Whitehead & Associates

Ref: 1912 RTC 220518sd

Re: Wastewater Assessment for North Byron Parklands

1. Introduction

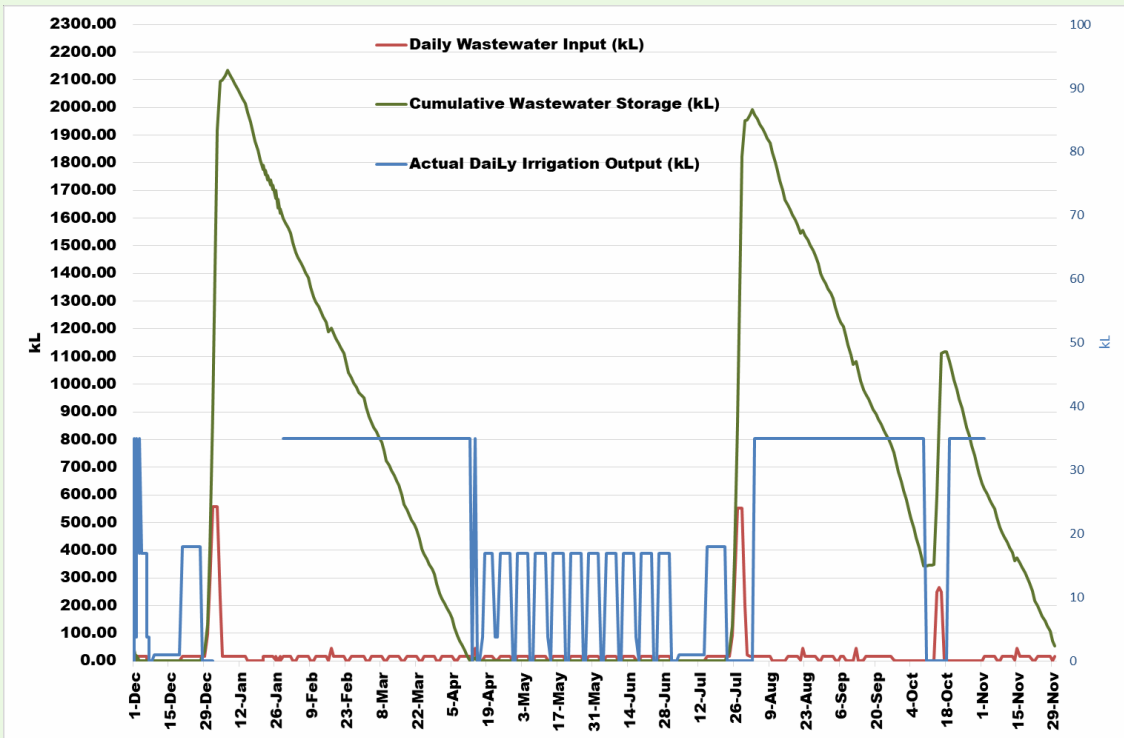
6G	The wastewater composition for on-site treatment is not substantiated with historic site data or other data.	<p>The NBP has been used as a cultural events site for approximately 5 years, and due to the nature of its trial approval has been relying on trucking in and out of water and wastewater. As such, data available is relatively short term and in-house.</p> <p>W&A were provided with and utilised water consumption and wastewater volumes that are utilised for planning purposes for the Falls and Splendour in the Grass festivals for the years 2014 and 2016 for Falls and 2015, 2016 and 2017 for Splendour in the Grass (see table below).</p> <p>As such the 1.4ML wastewater generation assumed by W&A, and JED Civil's estimate of 2.34ML potable water demand for the current SITG festival are accurate.</p> <p>Wastewater production has been reducing as new water consumption reduction methods have been introduced, in particular the progressive introduction of compost toilets.</p>

<p>Tables 7 and 8 of the WWA provide a breakdown of wastewater production for the events from 2015-2017 into the various sources and type of wastewater.</p>	Source	Water Supply (kL)*	Wastewater Production (kL)				WW:W**			Grey	Black	Catering	Total	Total Less	Total	No Catering	Falls 2016	2,541	1,106	146	133	1,386	1,253	0.55	0.49	Falls 2017	1,579	899	165	66	1,130	1,064	0.72	0.67	Falls 2018	2,426	1,008	159	60	1,227	1,167	0.51	0.48	SITG 2014	2,460	1,139	272	177	1,588	1,411	0.65	0.57	SITG 2015	2,091	1,218	269	161	1,648	1,487	0.79	0.71	SITG 2016	2,347	1,135	354	210	1,699	1,489	0.72	0.63	SITG 2017	2,341	793	269	168	1,230	1,062	0.53	0.45	* Includes dust suppression, fire tanks, medics, urinals, showers, catering, laundry									** Ratio of wastewater production to water supply								
Source	Water Supply (kL)*	Wastewater Production (kL)				WW:W**																																																																																													
		Grey	Black	Catering	Total	Total Less	Total	No Catering																																																																																											
Falls 2016	2,541	1,106	146	133	1,386	1,253	0.55	0.49																																																																																											
Falls 2017	1,579	899	165	66	1,130	1,064	0.72	0.67																																																																																											
Falls 2018	2,426	1,008	159	60	1,227	1,167	0.51	0.48																																																																																											
SITG 2014	2,460	1,139	272	177	1,588	1,411	0.65	0.57																																																																																											
SITG 2015	2,091	1,218	269	161	1,648	1,487	0.79	0.71																																																																																											
SITG 2016	2,347	1,135	354	210	1,699	1,489	0.72	0.63																																																																																											
SITG 2017	2,341	793	269	168	1,230	1,062	0.53	0.45																																																																																											
* Includes dust suppression, fire tanks, medics, urinals, showers, catering, laundry																																																																																																			
** Ratio of wastewater production to water supply																																																																																																			
7G	Proposed wastewater storage capacity of 2.2 ML will fill on day 4/5 of a large event.	<p>The Falls and Splendour in the Grass events currently operate for three to four days only. W&A modelled the events over a seven day ramp up and leaving cycle plus a lead up build period. A detailed storage balance for 393 day cycle was modelled to confirm the maximum storage required. See the appendices of the WWA for the storage calculations.</p> <p>The storage capacity is considered to be satisfactory.</p>																																																																																																	
8G	Significant reed bed overloading will occur on days 5 – 7 of a large event with the consequence that chlorine (or UV) treatment will be ineffective.	<p>W&A's modelling indicates that there would be no reed bed overloading.</p> <p>The treatment train has been designed to hold all wastewater for a total of 9 days prior to and following the two large events, with subsequent controlled 35kL/day release through the primary tanks and reed beds. This was modelled in the storage calculations.</p> <p>See the appendices of the WWA for the storage calculations and graph below that was included in the WWA.</p>

Revised storage balance chart with an increase in wastewater generation by 10%.

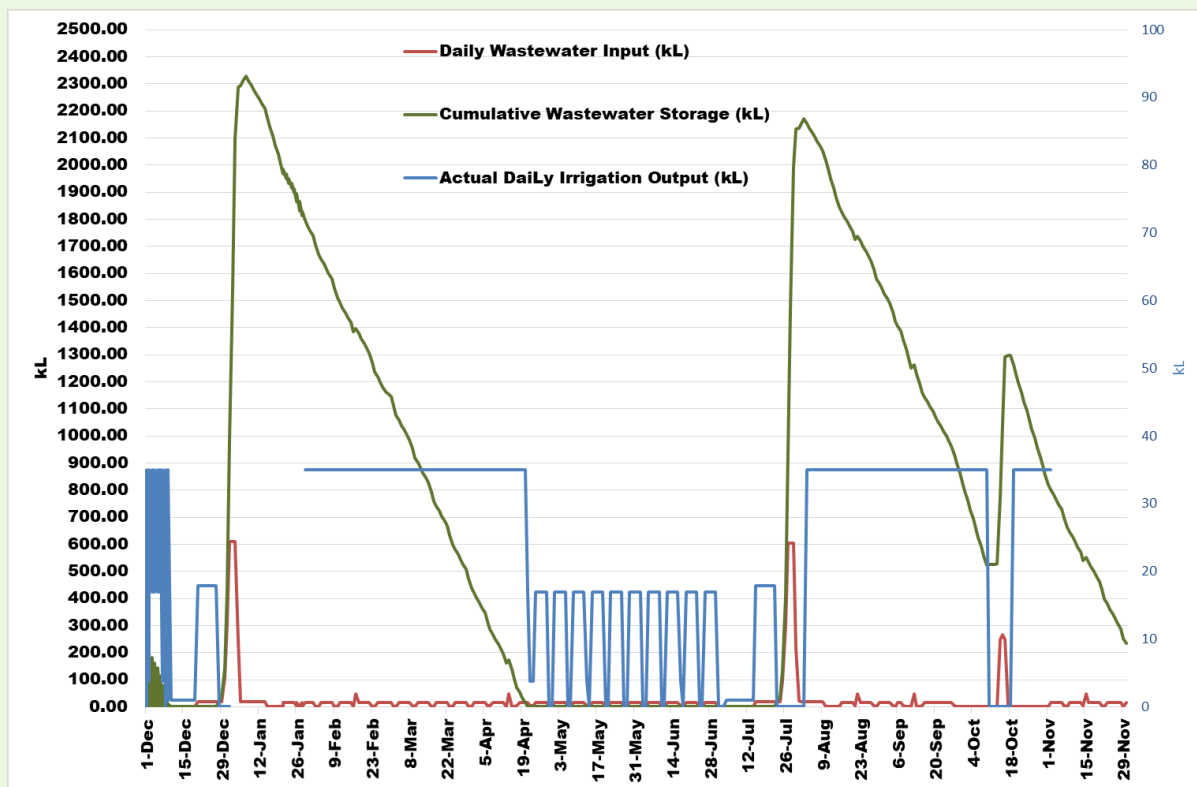
Item	GHD Recommendation	Response
13G	Water demand and waste water discharge values proposed are not possible to be reconciled based on the data presented. Clarification and substantiation are required for the discrepancies in the Appendices Q and R in terms of proposed water demand and waste water discharge volumes.	<p>See response to comments 2-4G above. The water demand calculation in the potable water assessment was overly conservative and cannot be directly related to wastewater production given the disconnect between water use and wastewater production at the site.</p> <p>The conservative water demand calculations is not problematic to the proposal, and would only result in larger storage tanks that are underutilised.</p>

Item	GHD Recommendation	Response
		<p>W&A undertook a more nuanced and detailed calculation of wastewater production requirements, given the more significant effect that wastewater volumes have on infrastructure requirements.</p> <p>No modifications are considered to be required.</p> <p>Higher than estimated wastewater production would result in requirement for increased storage capacity only. There is generally sufficient factor of safety built into the irrigation cycling to allow the 35kL/day treatment and irrigation to continue for slightly longer than allowed to cope with any total annual extra wastewater production.</p> <p>Given the volumes in the short time frame generated, the two large festivals would provide the biggest risk to wastewater storage requirements. As a contingency in the unlikely occurrence, during a large event offsite emergency disposal would be possible.</p> <p>W&A have undertaken a sensitivity analysis of the risks associated with increased wastewater from the two large festivals. An increase in wastewater production by say 10% would increase maximum storage requirements by approximately 10% (to 2.33ML up from 2.1ML), resulting in an extension of the timing of the storage resetting to 0ML (at 35kL/day treatment) by 6-8 days into April and December. See below for the revised storage balance chart with an increase in wastewater generation by 10%. Alternatively, with a 10% increase on wastewater production, increasing the treatment train capacity to 37kL/day would maintain the existing modelled timing of storage at 0ML at the beginning of April/December, increasing the irrigation area by about 6% to 38,000m².</p> <p>There is ample irrigation area available on the NBP site such that there is the opportunity to increase wastewater application further.</p> <p>Installation of the OSMS early in the staging process will enable flow meters to be installed and reliable data collected of the storage and irrigation volumes, thereby allowing tweaking of the storage, treatment train and irrigation design as required.</p>
